Model: Mojito-C2		Date: 2-Jun-03	No.: RB098001
Subject: BICU firmware Modification History		Prepared by: F.Noguchi	
From: 2nd Tech. Support Sec. Service Support Dept.			
Classification:	<input type="checkbox"/> Troubleshooting <input type="checkbox"/> Part information <input checked="" type="checkbox"/> Action required <input type="checkbox"/> Mechanical <input type="checkbox"/> Electrical <input type="checkbox"/> Service manual revision <input type="checkbox"/> Paper path <input type="checkbox"/> Transmit/receive <input type="checkbox"/> Retrofit information <input checked="" type="checkbox"/> Other (      )

The following is for the Mojito-C2 only, and is a reissue of RTB #RA293028c since a request from the field was received to issue RTBs for the C1 and C2 separately. Mojito-C2 RTBs will contain the prefix RB098.

Model: Mojito-C2	Date:8-Apr-09	No.: RB098002
------------------	---------------	---------------

Subject: Defective service part - Hot roller		Prepared by: K. Yamamoto	
From: 1st Overseas Tech Support Sec., 1st PQM Dept.			
Classification:	<input checked="" type="checkbox"/> Troubleshooting	<input type="checkbox"/> Part information	<input type="checkbox"/> Action requi

### 53.DRIVE SECTION 1 (A292/A293/B098)

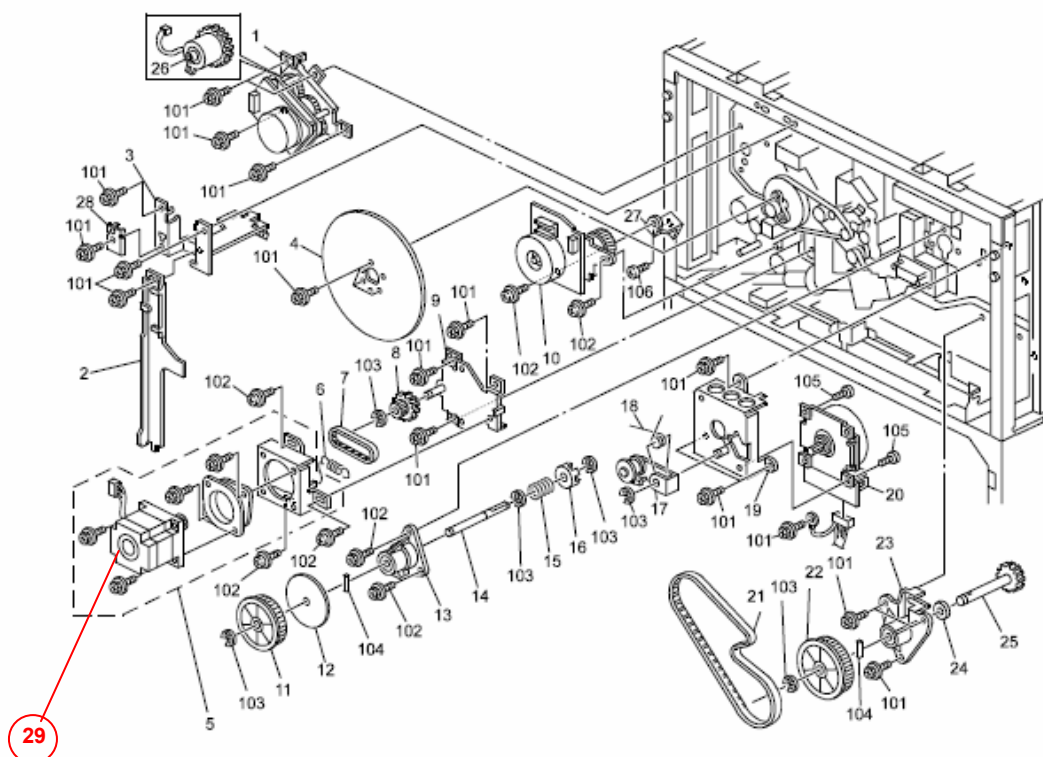
Old part number	New part number	Description	Q'ty	Int	Page	Index	Note
-	AX060151	STEPPER MOTOR: REGISTRATION	1	-	119	29	New Index
AX060151	B1401037	STEPPER MOTOR: REGISTRATION	1	O/O	119	29	New index

**Note:** The following part (index#29) was registered as a service part.

See photos and affected lot numbers below.

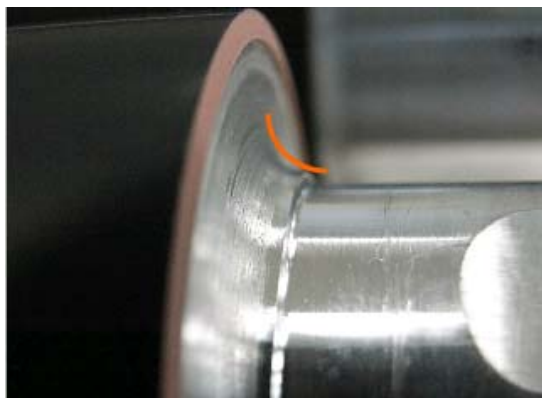
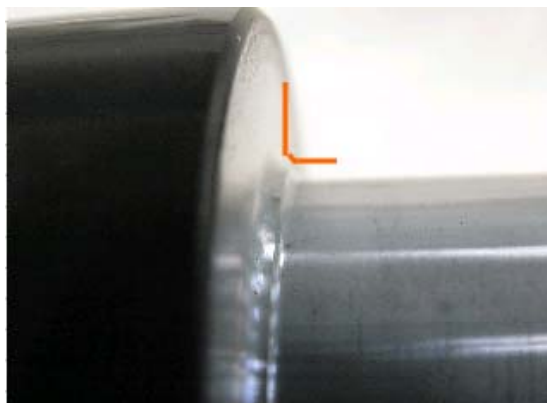
The ring stopper cannot be attached to the hot roller (AE011073) when the roller is replaced.

The edges of the shaft section on some hot rollers in service parts stock were not ground to a 90-degree angle.

Incorrect:

Correct:

If the symptom occurs, and the lot number of the hot roller is in the following range, replace the roller.

Affected lot numbers: **A110510 – A310810** (May 11 and August 31)
